**TO:** Cochise County Planning and Zoning Commission  
**FROM:** Christine McLachlan, AICP, Planning Division Manager  
**FOR:** Daniel Coxworth, AICP, Development Services Director  
**SUBJECT:** SU 23-17 (3 Sisters Solar), Application for a Special Use Authorization  
**DATE:** July 31, 2023, for the August 9, 2023, Meeting

**Docket SU 23-17 (3 Sisters Solar)**

Figure 7: Array spacing Diagram

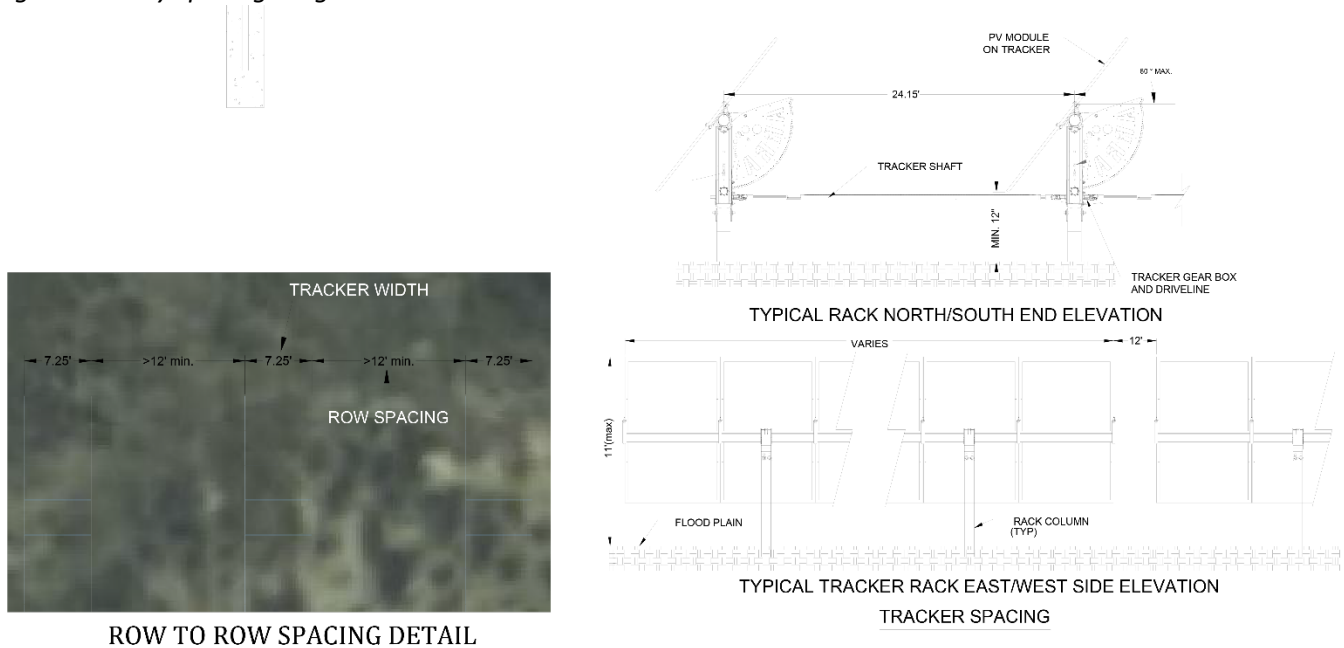
From a project functionality standpoint, recent studies have shown that increased spacing of solar panels comes with benefits. Moving rows of solar panels farther apart can increase efficiency and improve economics in certain instances by allowing greater airflow to direct heat away. The increased spacing also allows greater wind flow, which can result in lower module temperatures and higher energy output. Greater spacing is also believed to reduce the "lake effect," in which continuous closely spaced panel arrays create an optical illusion of water. For these reasons, staff recommends a condition, specifying clearance distance between array rows.

- ***Recommended COA: The project owner shall exclusively use PV panels with an anti-reflectivity coating that is integral to the panel.***
  - ***Recommended COA: To reduce the optical illusion of water that closely spaced panels can create, all solar racks shall be installed to maintain no less than a twelve (12) foot minimum clear distance, measured from outer edge of panels, between all tracker rows (north-south). The applicant shall not exceed a 35% ground cover ratio, defined as panel area to total project area, for the project site.***

7. The project owner shall submit a construction waste disposal plan in conjunction with building permit submittals for County review and approval.
8. To reduce the optical illusion of water that closely spaced panels can create, all solar racks shall be installed to maintain no less than a twelve (12) foot minimum clear distance, measured from outer edge of panels, between all tracker rows (north-south).

Figure 8: Floodplain Map

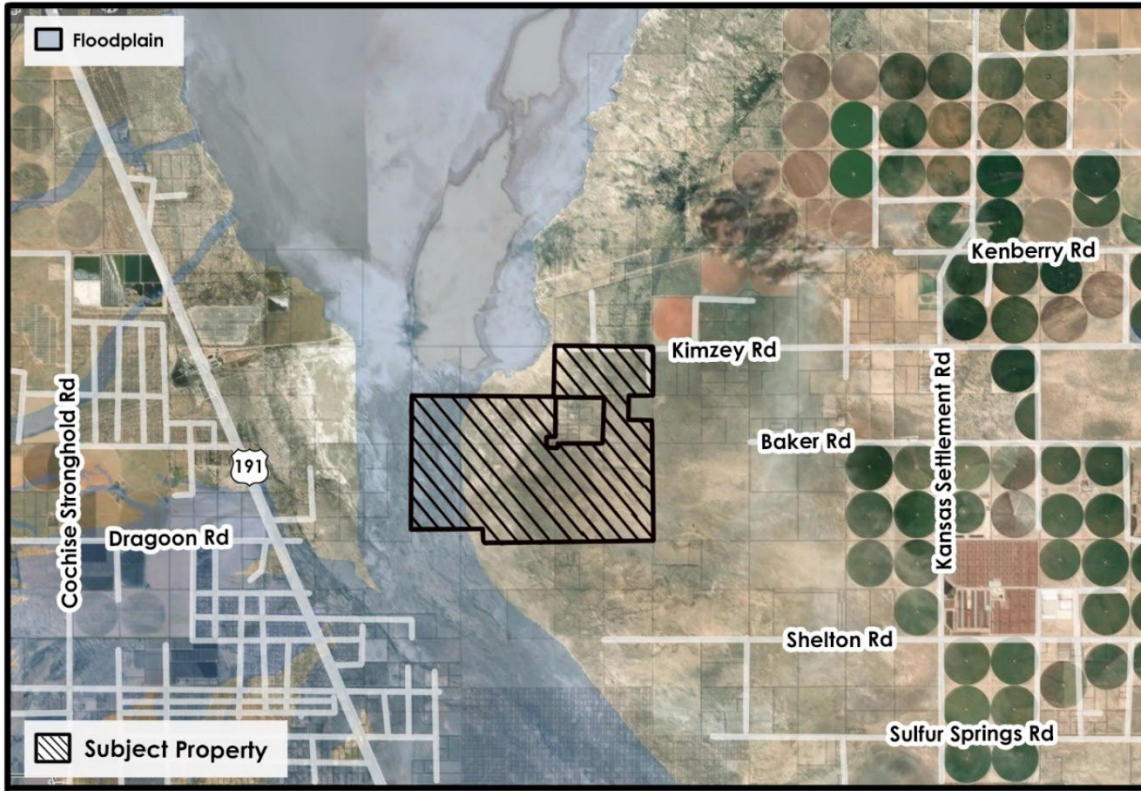
- Stormwater and Floodplains: The applicant submitted a pre-construction hydrology assessment with their application. As stated in the assessment, "The purpose of this analysis is to provide hydrologic and hydraulic calculations throughout the study area to support the construction of the Three Sisters Solar Project. Depth and velocity quantities are desired at solar array locations to determine conflict areas for the solar array. Additionally, scour depths are utilized to avoid pile supports in areas where the potential for weakened foundations may occur or to inform where scour protection may be required. The AHJ lies with Cochise County. Stormwater management requirements must follow the guidelines established by ADEQ and are managed by the state. Typical facilities can achieve acceptable water quality by conserving open space with large portions of project site remaining undisturbed in a natural state. Where required, the use of detention basins can achieve water quality requirements. The feasibility of the project is highly achievable and ideal for a solar energy facility due to the minimal grading necessary for typical development. A post-construction analysis is recommended to verify that the proposed grading doesn't negatively impacts the existing hydraulics." In addition, the County will require a drainage analysis and floodplain use permit for the site during commercial permitting, if approved for special use authorization.

WILDLIFE FRIENDLY SECURITY FENCE TYPICAL DETAIL \*

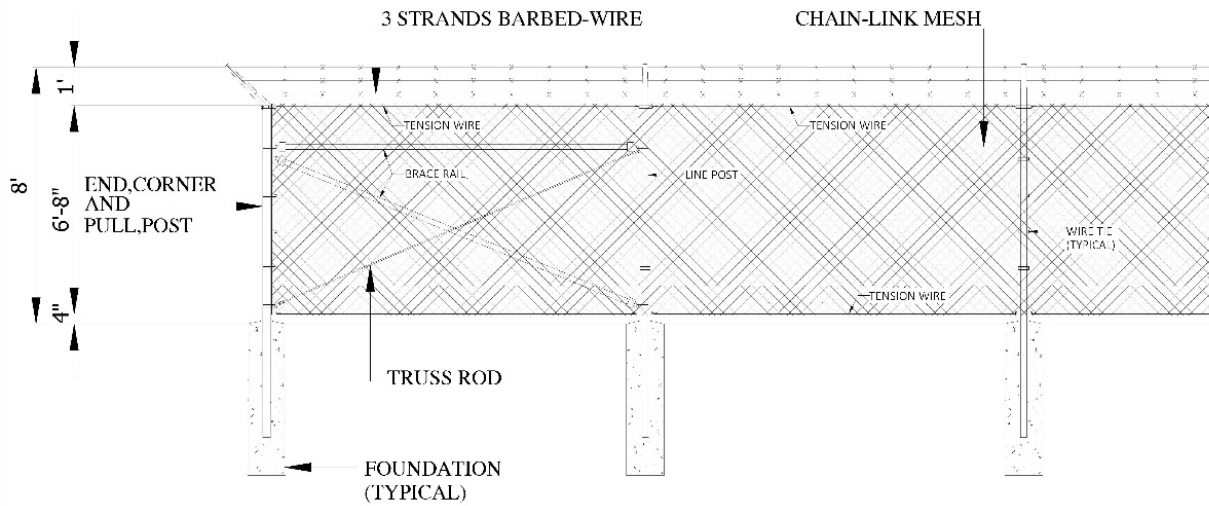
There is a 4” gap proposed from finished grade to the bottom tension wire of a chain link mesh fence. Three strands of barbed wire are proposed at the top.

The applicant states, “In our meetings with the Arizona Game and Fish Department (AGFD) for this Project, we reviewed fence height, bottom fence gap and fence types. It was determined that a 4-to-8-inch gap is acceptable in this location. AGFD accepts a 4-inch gap between the ground surface and bottom of the perimeter fencing for this Project, based on the smallest size that would accommodate kit fox permeability. The applicant proposes 4 inches for security reasons.”

It is up to the commission to determine whether the proposed fence meets the threshold to be considered wildlife friendly. Two of the most recently approved solar projects, one of which was recently constructed, include a larger 6-8” bottom gap. **Staff recommends, pursuant to 1824.03 of the Zoning Regulations, which mandates wildlife-friendly fencing, that the applicant reserve a 6–8-inch gap between the ground surface and the bottom of the perimeter fencing; however, applicant contends a 4-inch gap is sufficient to satisfy the requirement.**

3. Pursuant to 1824.03 of the Zoning Regulations, which mandates wildlife-friendly fencing, the applicant shall reserve no less than a 4-inch gap between the ground surface and the bottom of the perimeter fencing.
